UNITED STATES PATENT AND TRADEMARK OFFICE

APPLICATION NO.	FILING DATE	FIRST NAMED INVENTOR	ATTORNEY DOCKET NO.	CONFIRMATION NO.
09/746,065	12/26/2000	Daijiro Inoue	001700	1991

Office Action Summary	Application No.	Applicant(s)	
	09/746,065	INOUE ET AL.	
	Examiner	Art Unit	
	Armando Rodriguez	2828

FIG. 22**Claim Rejections - 35 USC § 103**

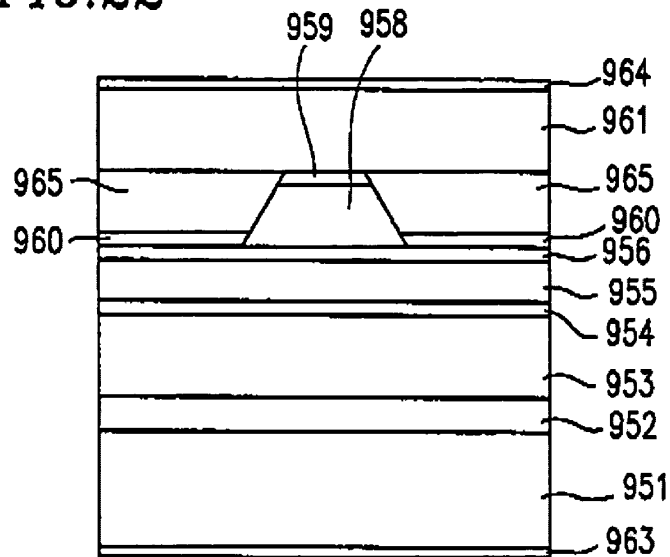
Claims 1-6,8,9,12,14,17-24,27-33 are rejected under 35 U.S.C. 102(e) as being anticipated by Okubo et al (PN 6,181,723).

In figure 22 Okubo et al illustrates a semiconductor laser having an active layer (954), a cladding layer (955) formed on the active layer, an etch stop layer (956) having a thickness of .003um, which is the same as applicant's depletion layer formed on the cladding layer, a current blocking layer (960), which is the same as applicant's low carrier concentration layer formed on the etch stop layer and a current block layer (965) having a higher carrier concentration than current layer (960), as described in column 22 example 10.

FIG. 5

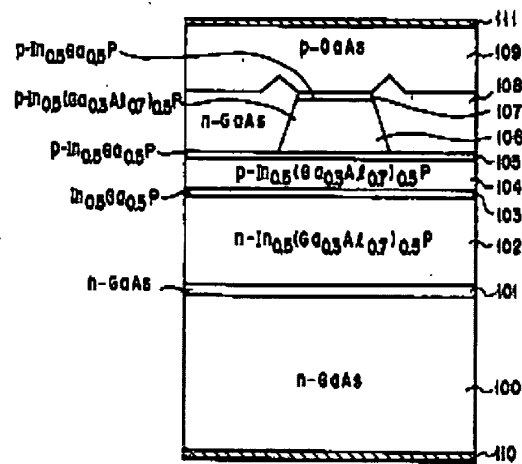
Claims 13, 15 and 16 are rejected under 35 U.S.C. 103(a) as being unpatentable over Nishikawa et al (PN 5,305,341).

It is well known in the laser art to use any of the claimed semiconductor materials to establish an ordered structure for a semiconductor laser, as illustrated in figures 5 and 10 of Nishikawa et al.
